SALEM NUCLEAR GENERATING STATION, UNIT NO. 2

AMENDMENT TO FACILITY OPERATING LICENSE

Amendment No. 30  
License No. DPR-75

ATTACHMENT TO LICENSE AMENDMENT NO. 30

FIGURE 3.2.2  
 $K(Z)$  - NORMALIZED  $F_0(Z)$  AS A FUNCTION  
 OF CORE HEIGHT

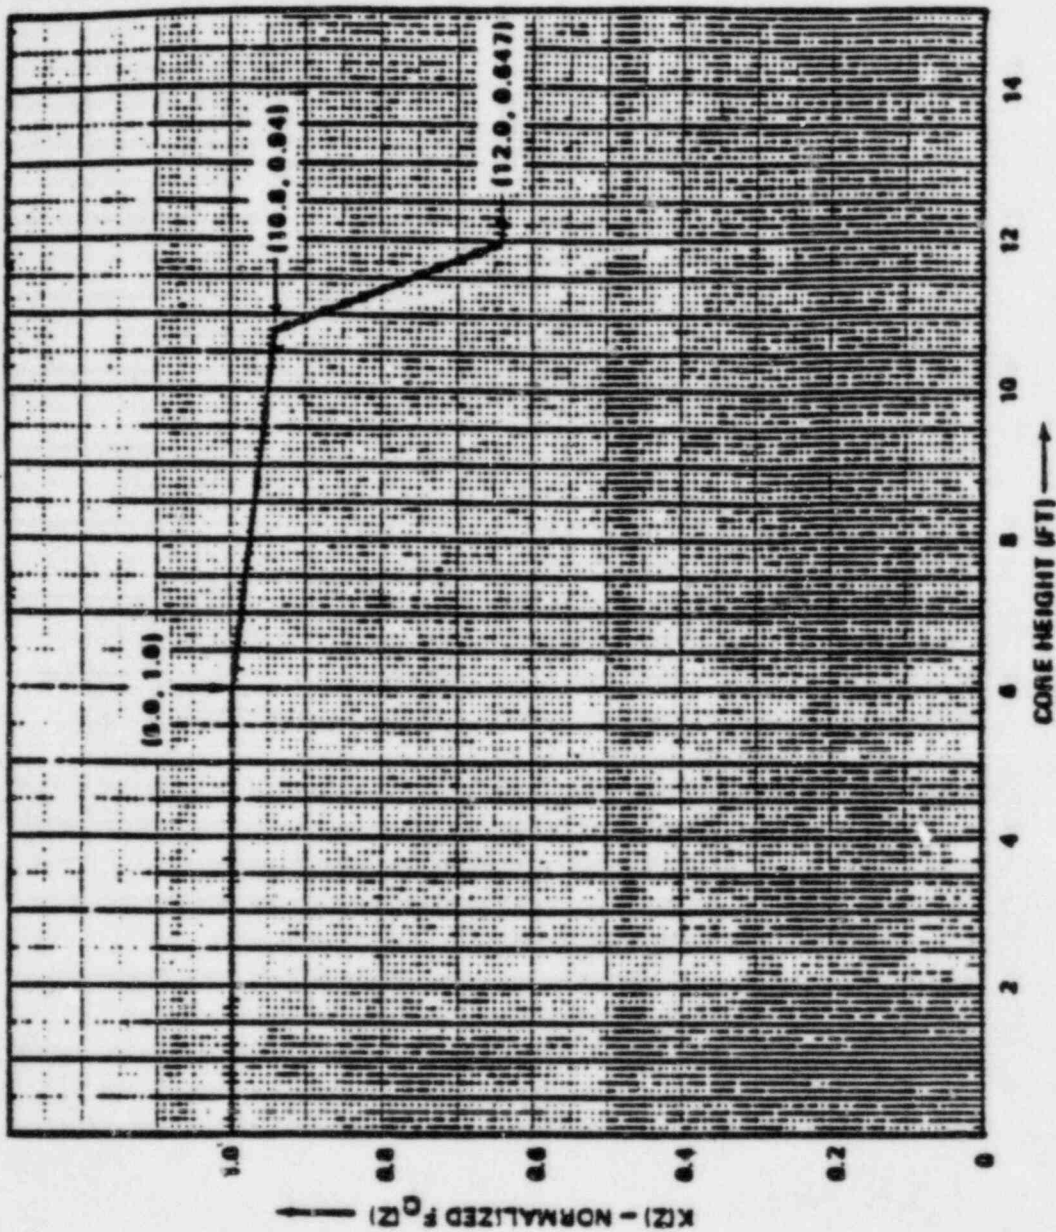
3/4 2-7

3/4 2-7

3/4 2-8

3/4 2-8
